Flight Procedures Cover Page	Task Action: FLIGHT CHECK	Task Type: IAP	Estimated Chart Date: 07/09/2026	APWS Task ID: A7CFEBA36F5745A7A7EC2E8A03E13504	APWS Project ID: 9A9289D5B30F4D6A98ACAE8C66E42871
Procedure: ILS Y OR LOC Y RWY 28 AMDT 5		Enroute: NO	Specialist: Weston, Daniel		Agreement Number:
Airport ID: PAOM			Airport City: NOME		State: AK
Facility ID: OME	Facility Type: ILS	Flight Inspection Remark Type: New FC Slot

1. FLIGHT PROCEDURE IDENTIFICATION:

Nome, AK
Nome (PAOM)(OME)
ILS Y OR LOC Y RWY 28

ILS Y or LOC Y RWY 28

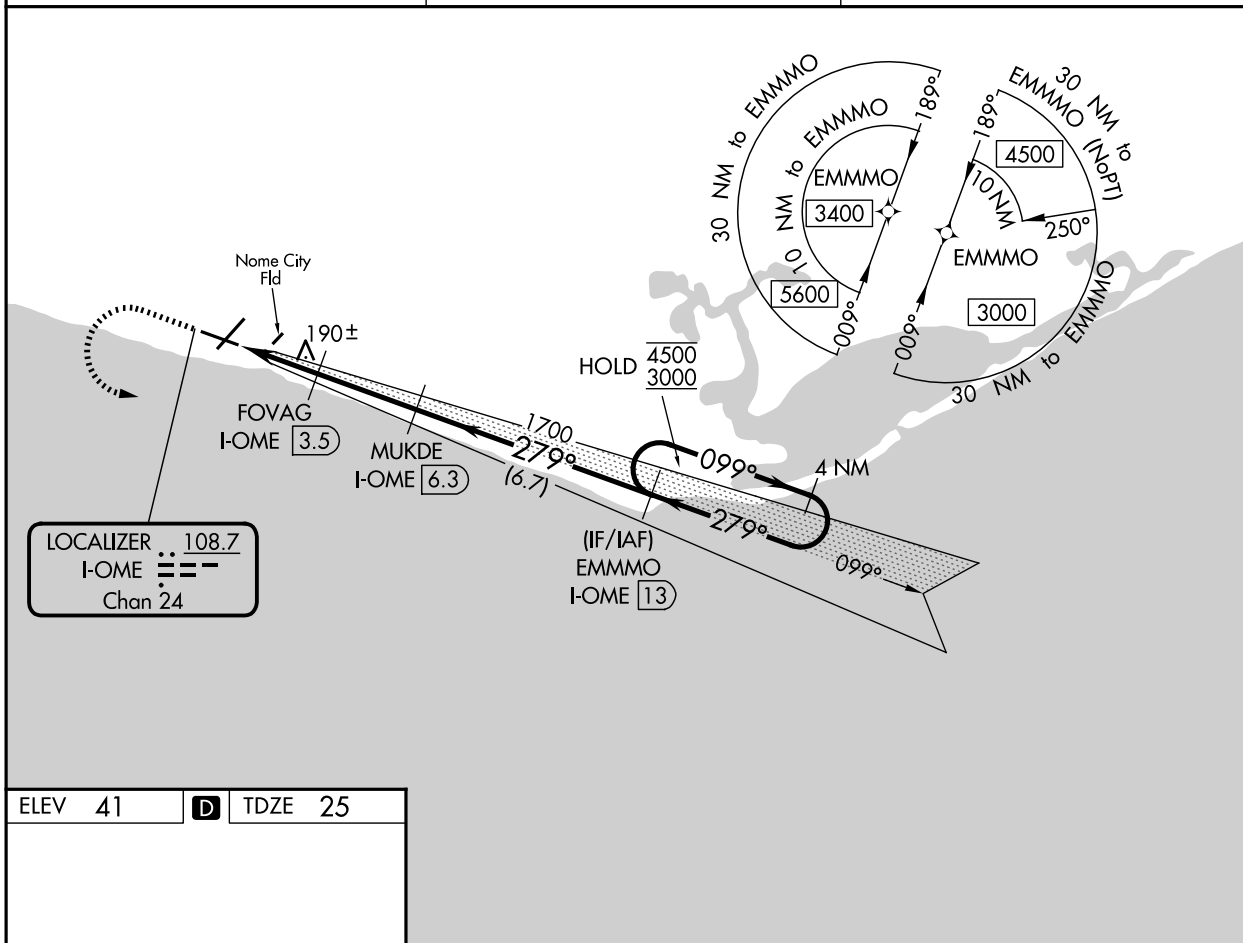
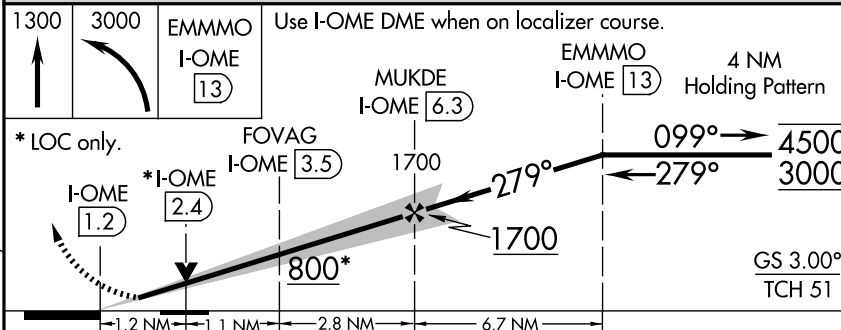
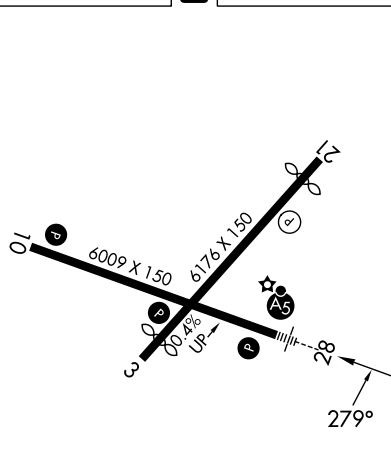
1. ADDED CHART NOTE: WHEN NOME FSS CLOSED, INCREASE VISIBILITY ALL CATS TO RVR 5000.
2. UPDATED CA LEG COURSE FROM "283.94" TO "283.77".
3. REMOVED CHART PROFILE NOTE: USE I-OME DME WHEN ON THE LOCALIZER COURSE.

▼ Circling Rwy 21 NA at night. Rwy 28 helicopter visibility reduction below RVR 4000 NA. For inop ALS, increase S-LOC 28 Cats A/B visibility to RVR 5500 and Cats C/D visibility to RVR 6000. Inop table does not apply to S-ILS Rwy 28. Circling NA for Cats C and D north of Rwy 10-28.
